## ORIGINATION FORM

### Proposed Revisions to a Standard Plans Index (Please provide all information — Incomplete forms will be returned)

Index Number: 370-001  
Sheet Number (s): 1 of 1  
Index Title: Bridge Approach Expansion Joint Concrete Pavement with Special Select Soil Base

SECTION A-A

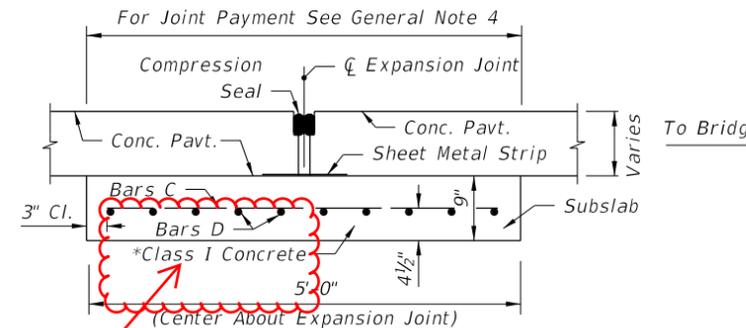
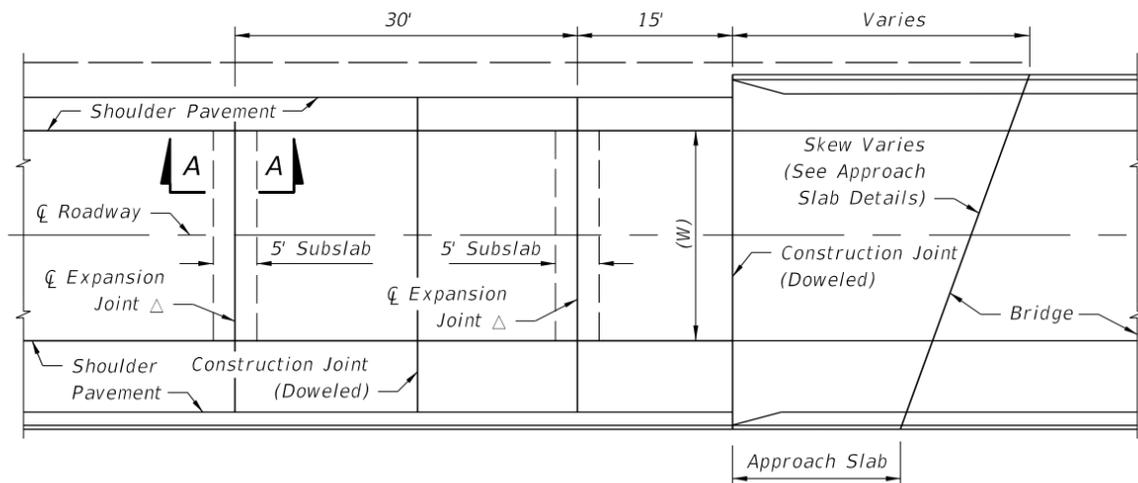
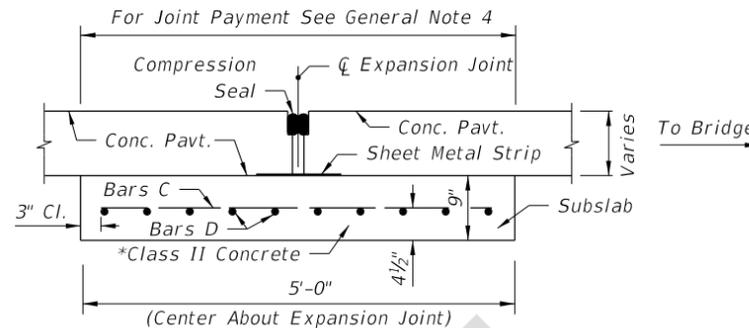
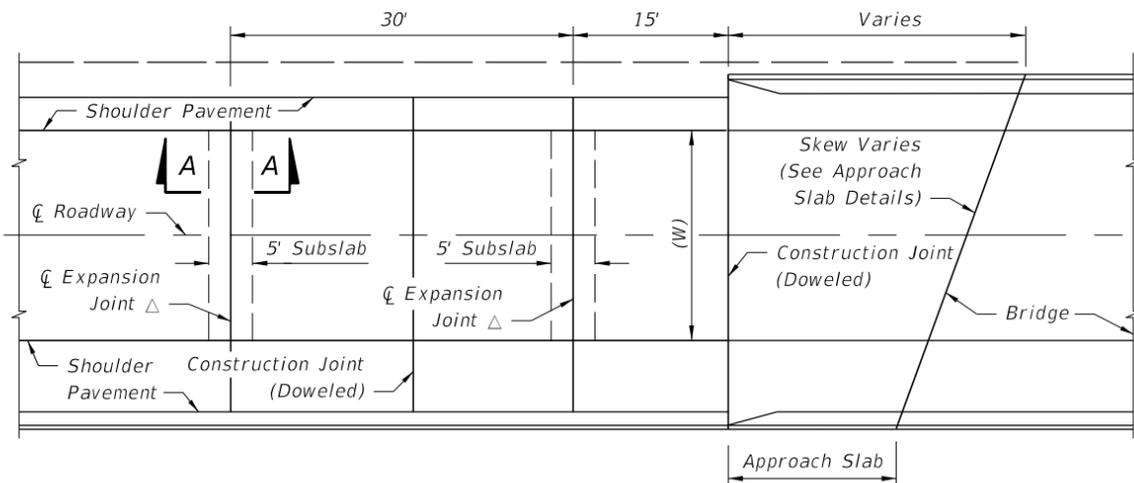
- Changed "Class I" to "Class II" in SECTION A-A.
- Revised Note 1 to read " For asphalt base, use four expansion joints, spaced at 15-ft, per Index 350-001."

Changed to Class II to reflect SMO Specification change that removes the designation for Class I Concrete. Please see the attached Standard Specification Section 346 DRAFT for the Class I revisions proposed by the State Materials Office.

CHANGED TO: Class II
